AUSTIN ROVER

BULLETIN
MAESTRO TECHNICAL

Item 9

COOLANT LEAK FROM RADIATOR
 (Issue 2 to correct part nos.)

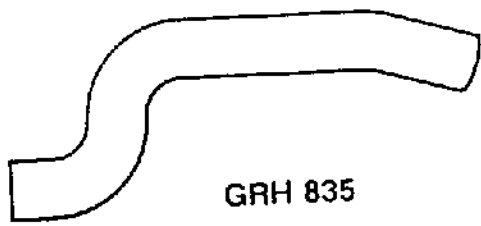
A foul condition between cable and fresh air duct and/or wiring harness.

- 1 Disconnect battery and remove wiper motor plenum cover.
- 2 Remove instrument pack and speedometer cable.
- 3 Detach foam material from upper surface of right hand face level duct adjacent to speedometer cable.
- 4 With a pad saw or a heavy duty craft knife, cut a "V" section approximately 32 mm wide and 15 mm deep from the right hand face level vent duct, as shown in illustration. Ensure that any swarf or small particles are removed.
- 5 Cover cut area of duct with black waterproof tape, forming a suitable depression to provide clearance for cable.

- 6 Check position of wiring harness to ensure that it will not foul speedometer cable when re-assembled. Fit new cable and refit original instrument pack, ensuring speedometer cable is positioned centrally in cut-out section of heater duct to avoid fouling. It is necessary to fit a new cable as abnormal wear will have taken place within the cable where it has fouled the duct or the harness.

fig. 9/1

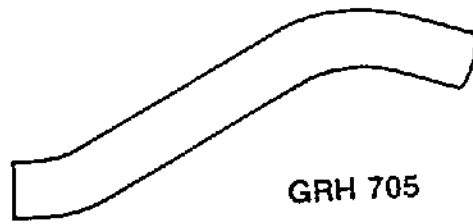
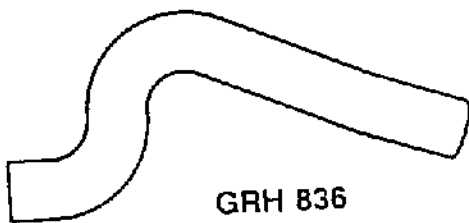
Radiator damaged by engine vibration transmitted via excessively rigid top hose.

More flexible top hose introduced at vin:

A modified hose can be identified as shown (see illustration) and, where this problem is encountered, one should be fitted at the same time as a replacement radiator to avoid recurrence.

Maestro GRH 705 GRH 835

Maestro van GRH 714 GRH 836

Montego GRH 705 GRH 835

fig. 11.1

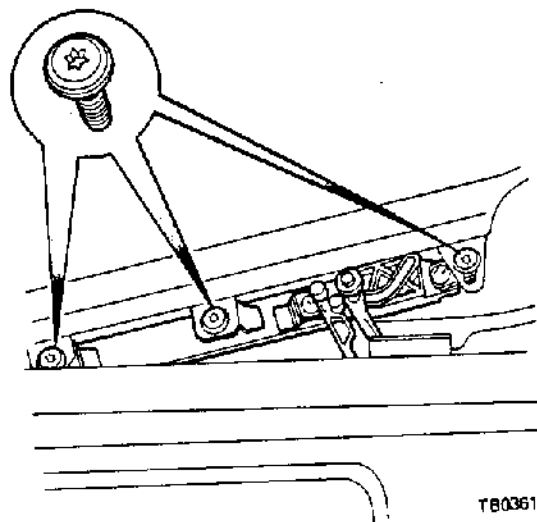
With this change, a different type of culisse fixing screw has also been introduced and UNDER NO CIRCUMSTANCES should the earlier type of screw be used with a plastics culisse - see illustration.

BYP 1004 screw, Power-Lok 3 per culisse

The new screws are recognisable by their being blue in colour as opposed to the black colour of the earlier type
